**E-54 Regional Lift Station - RFCSP
Solicitation Number: CO-00537
Job No.: 22-2502**

**ADDENDUM 2
October 25, 2022**

FORCE MAIN CONNECTION NOTES

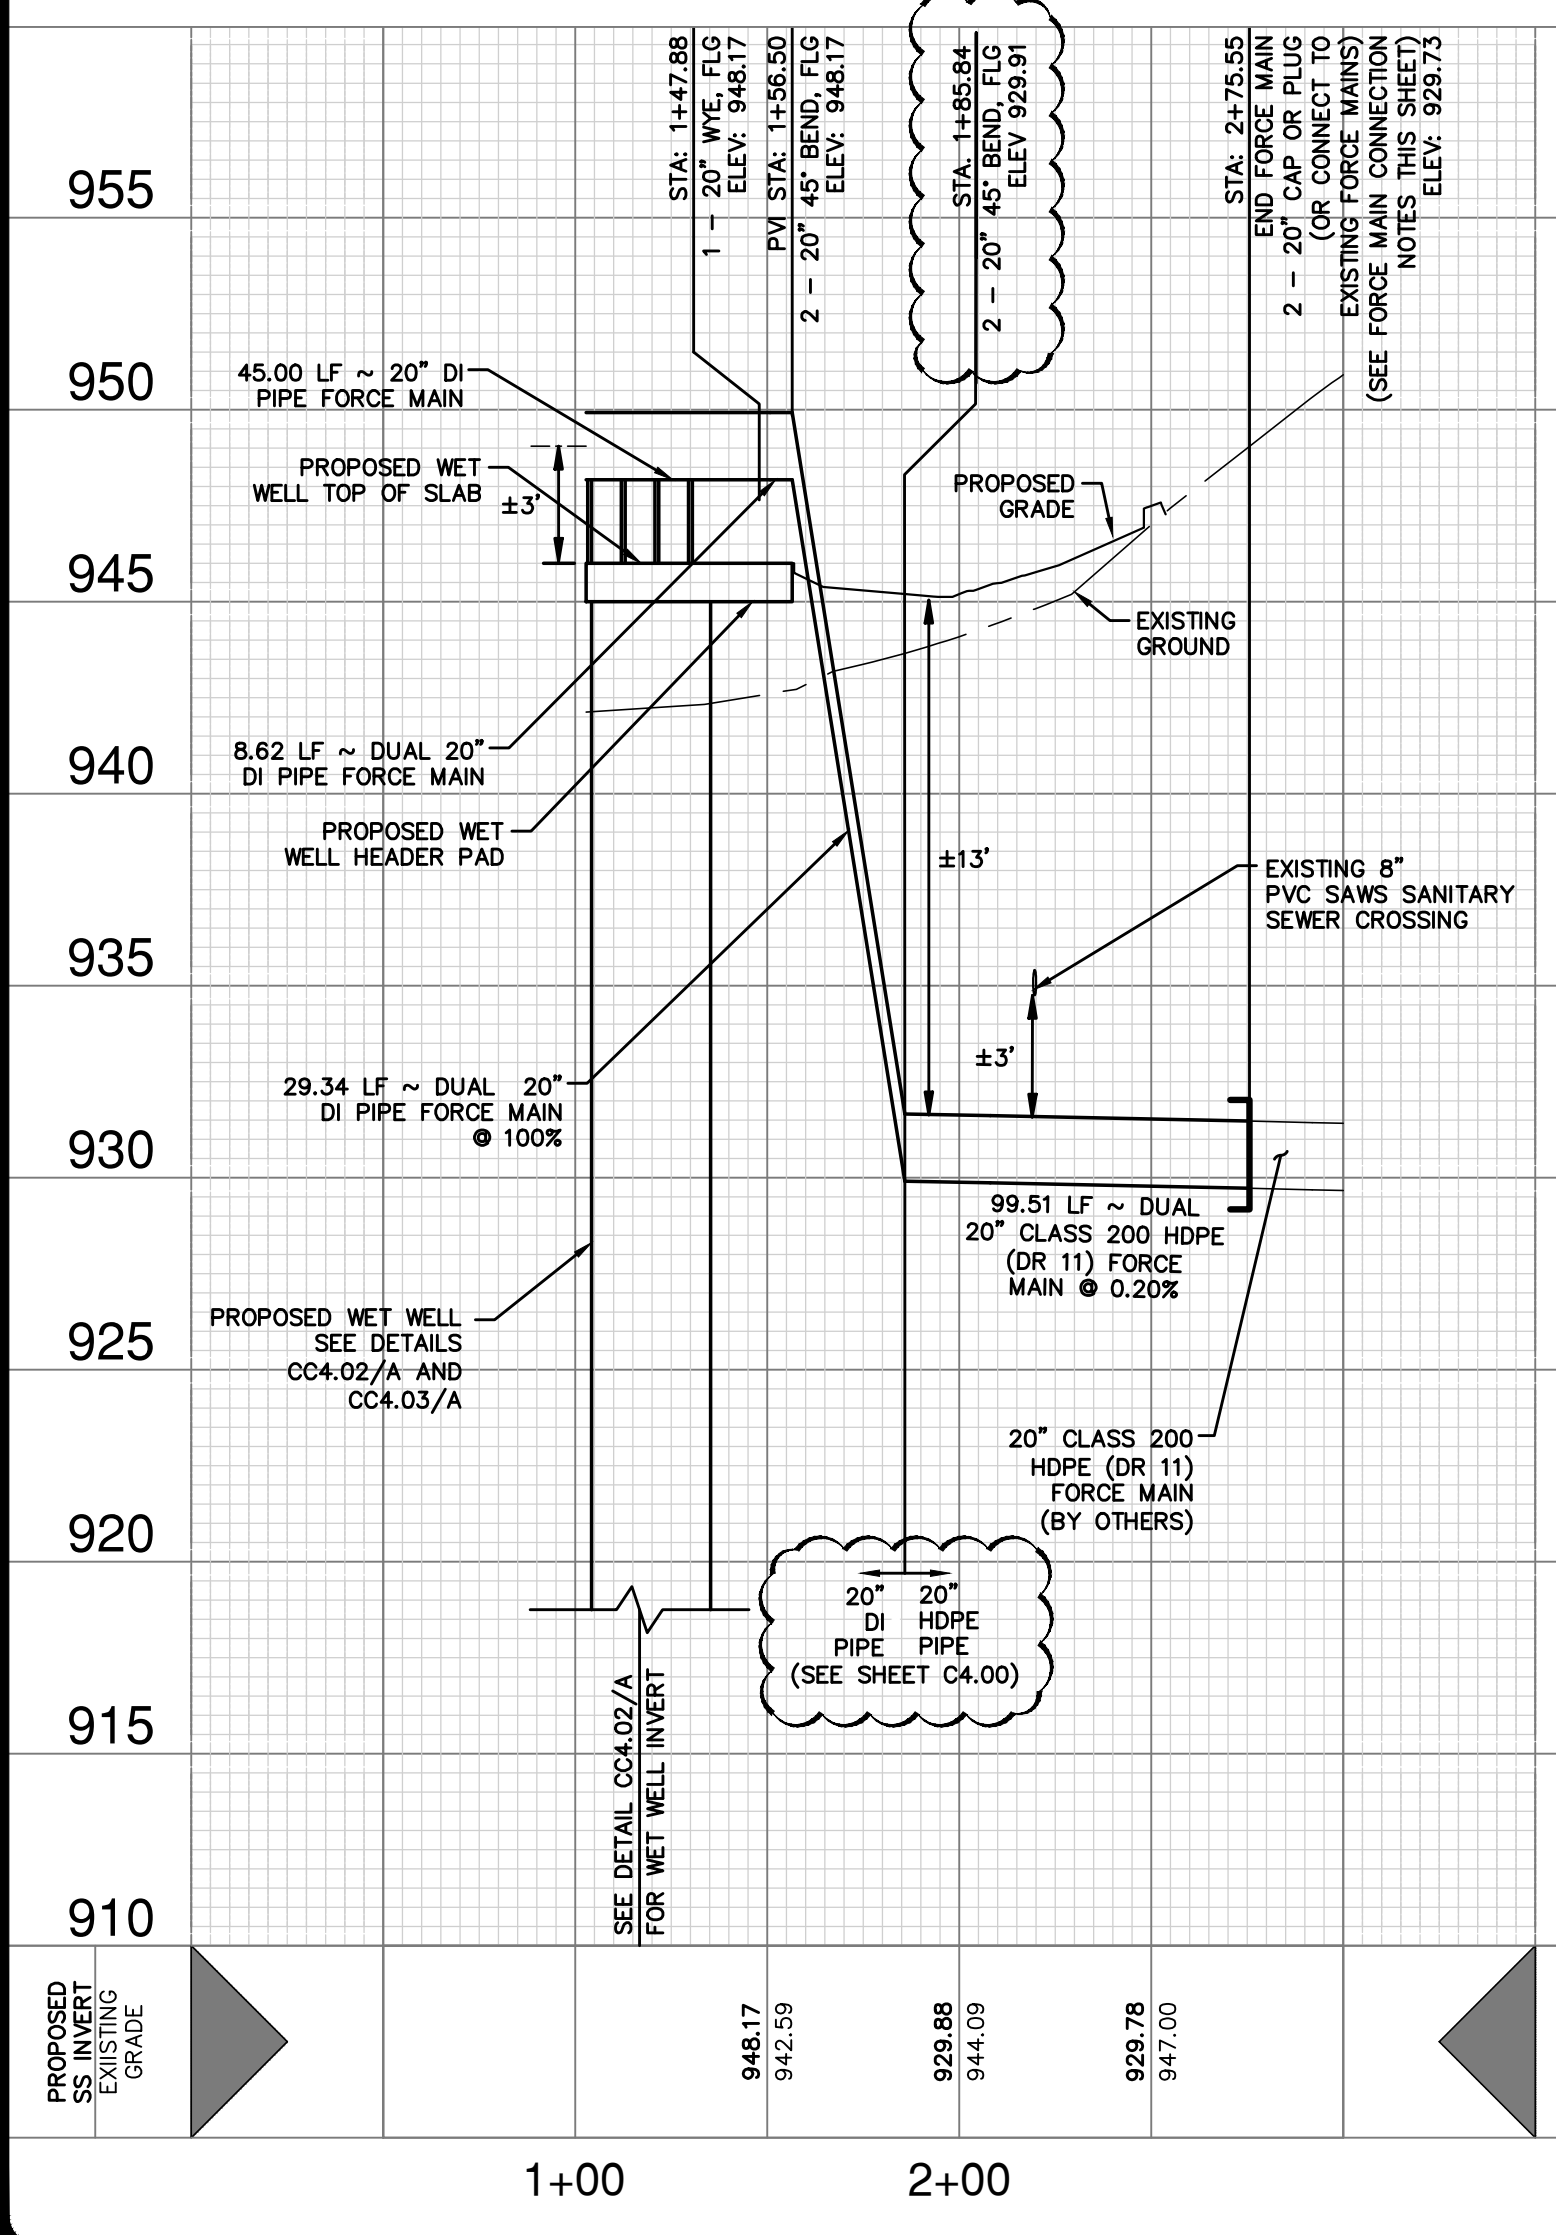
There are discrepancies between dimensions of Sheet E4.00 as compared to E10.00 as well as other electrical building plans. When scaling the foundation of the electrical building on E4.00, it gives a dimension of 32'x14'. Using the scale provided on E10.10 through E10.20 the foundations show to be 37'8"x15'8", same as shown for architectural plans. Site dimensional control Sheet C2.01 seem to indicate the building foundation is 32'x14'. Same goes for other structures on site having different dimensions between site dimensional control plan and individual structural plans. Please clarify which scales are to be utilized.

RESPONSE: Sheet C2.00, C2.01, Sheet C3.00, and E4.00 are revised to show correct interior electrical building and wetwell dimensions and dimensional controls of 36'x14' and interior wetwell dimensions of 35'x35', respectively. Contractor shall refer to structural drawings for foundation perimeter dimensions for these structures. See Changes to the Plans #1, #2, #3, and #9.

SAWS JOB NO. 22-2502
 JOB NO. 11500-51
 DATE SEPTEMBER 2022
 DESIGNER RM
 CHECKED DRAWN
 SHEET **C4.00**

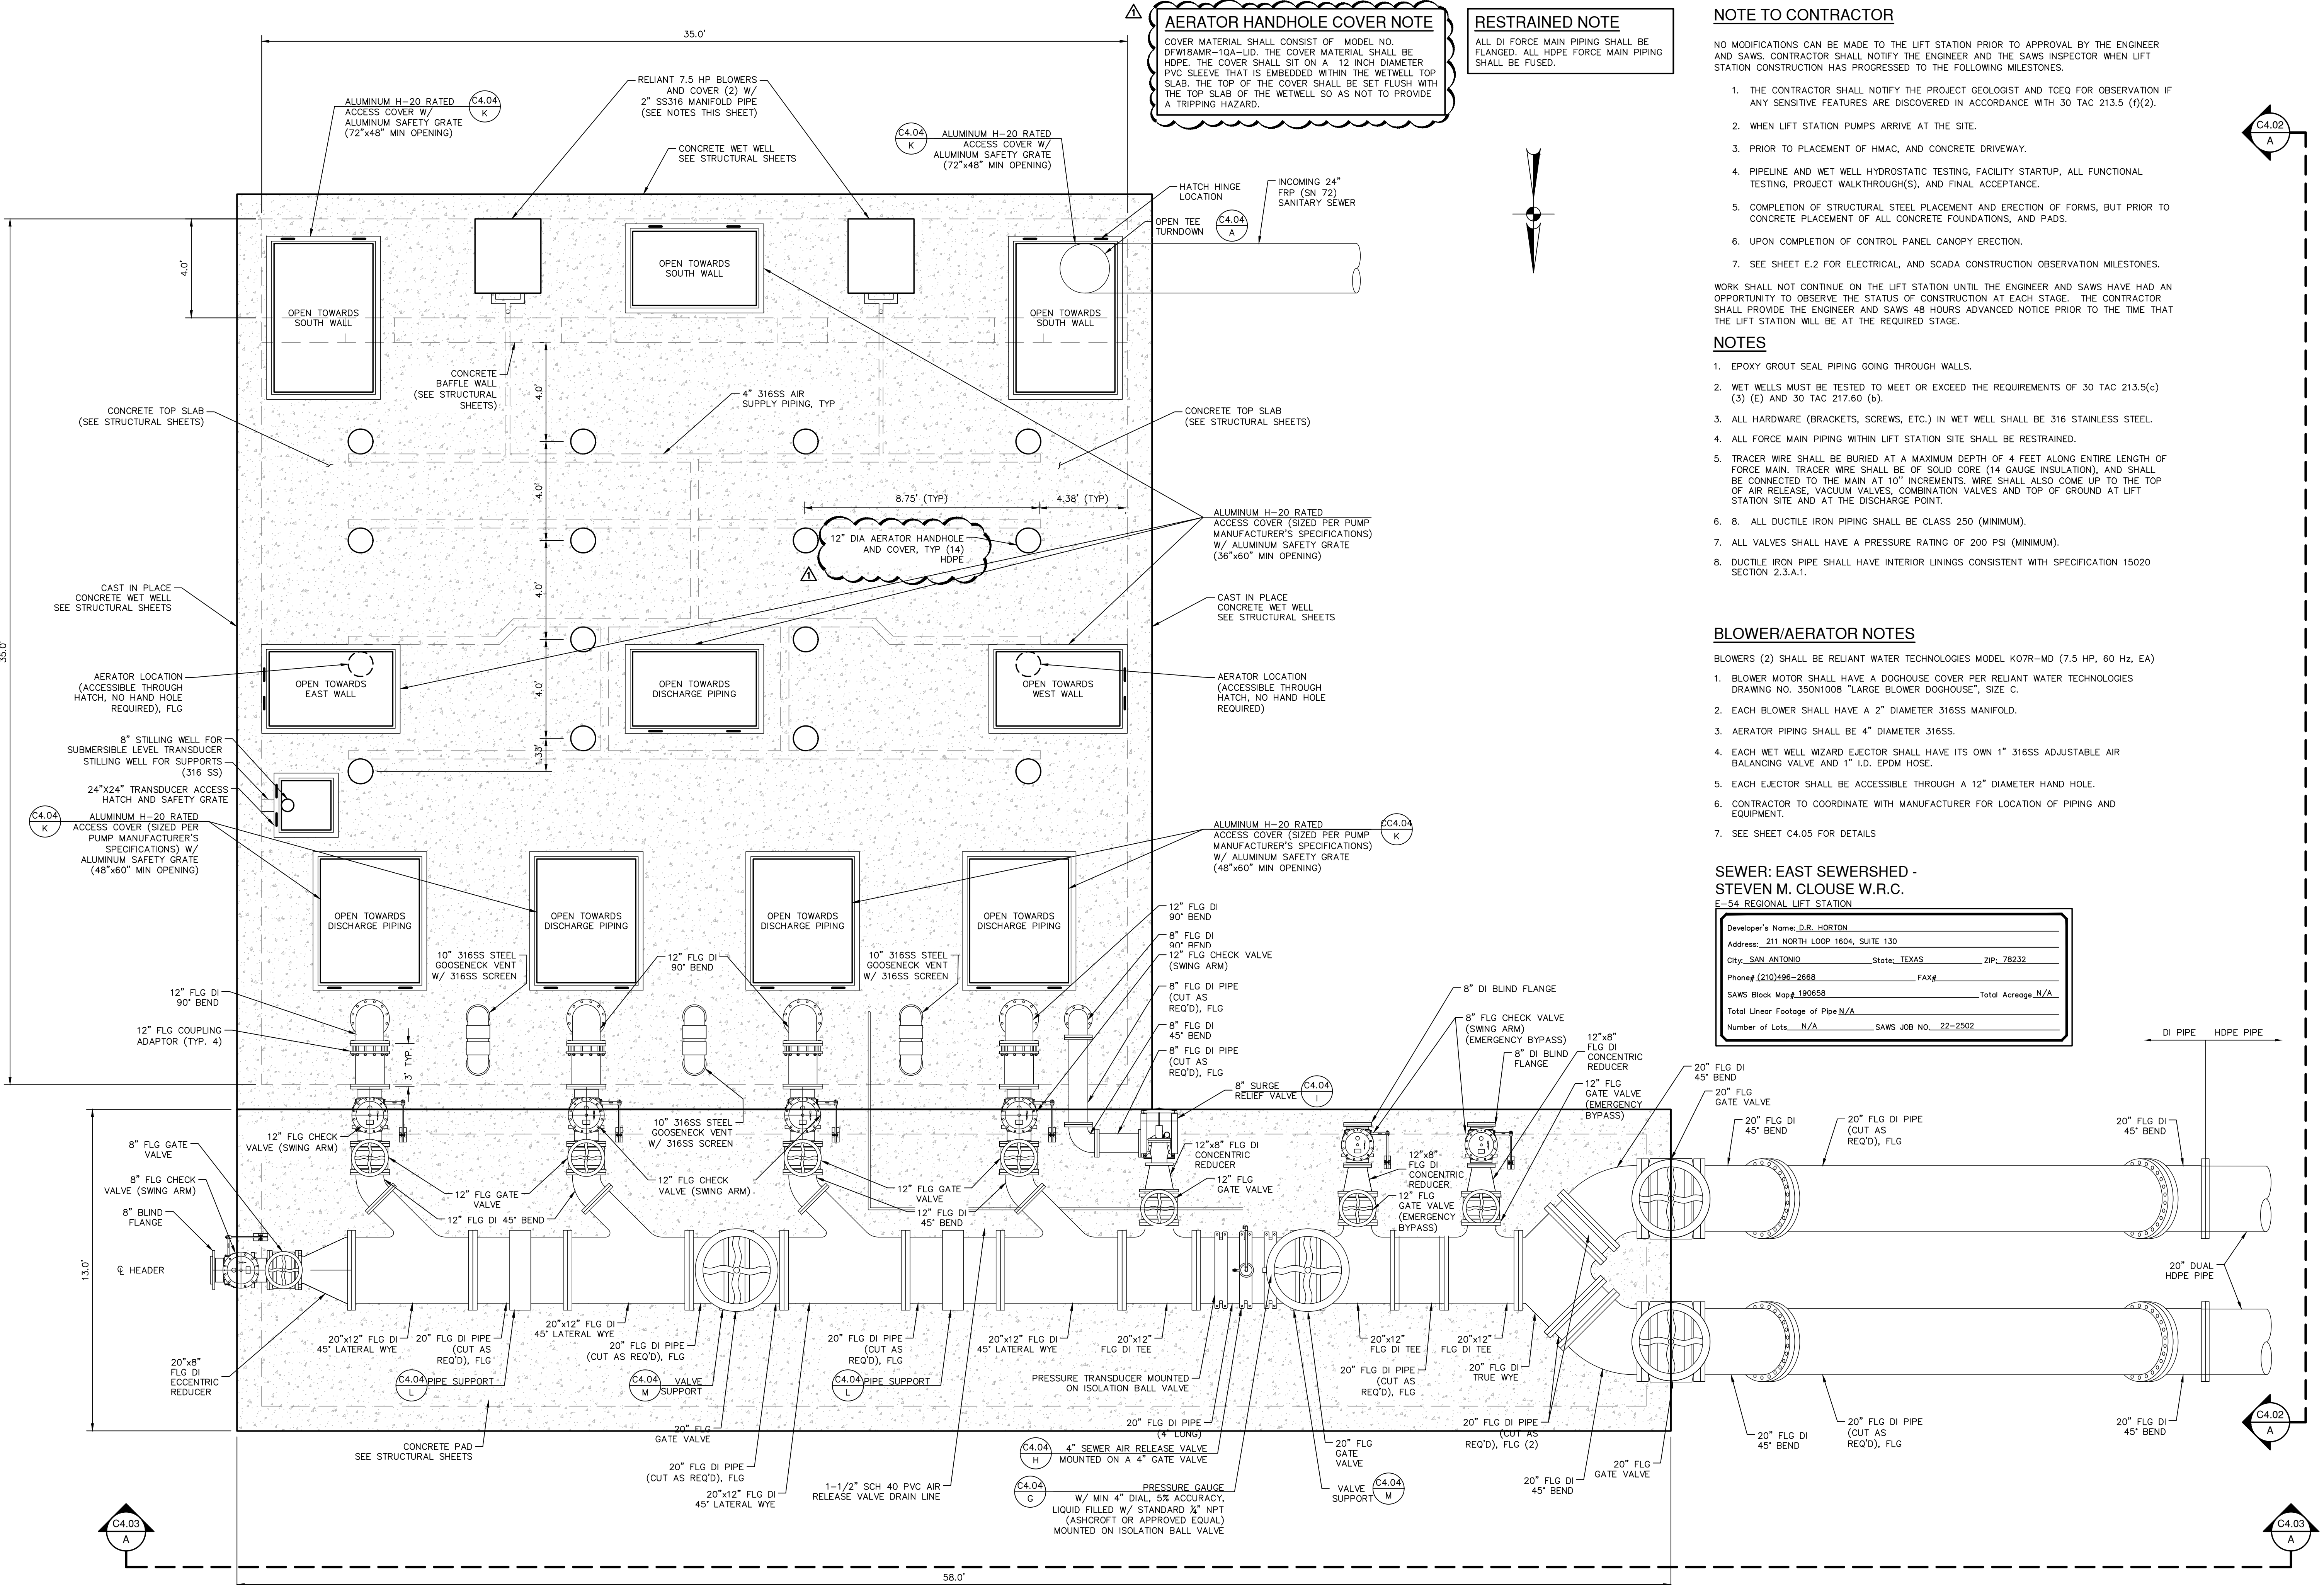
Ref Sheet C4.00. There are several 12" holes in the slab for handholes. Do you have a detail for the cover that would be required for these holes?

Ref Sheet C4.00. The Stainless Steel Aerator Piping poured in the slab. Do you require a wrap or anything around the stainless steel that is poured into the concrete slab?

RESPONSE: The cover material shall consist of DFW Plastics, Inc. (PO Box 648, Bedford, TX) model number DFW18AMR-1QA-LID. The cover material shall be HDPE. The cover shall sit on a 12-inch diameter PVC sleeve that is embedded within the wetwell top slab. The top of the cover shall be set flush with the top of the wetwell slab so as not to provide a tripping hazard.

RESPONSE: No.
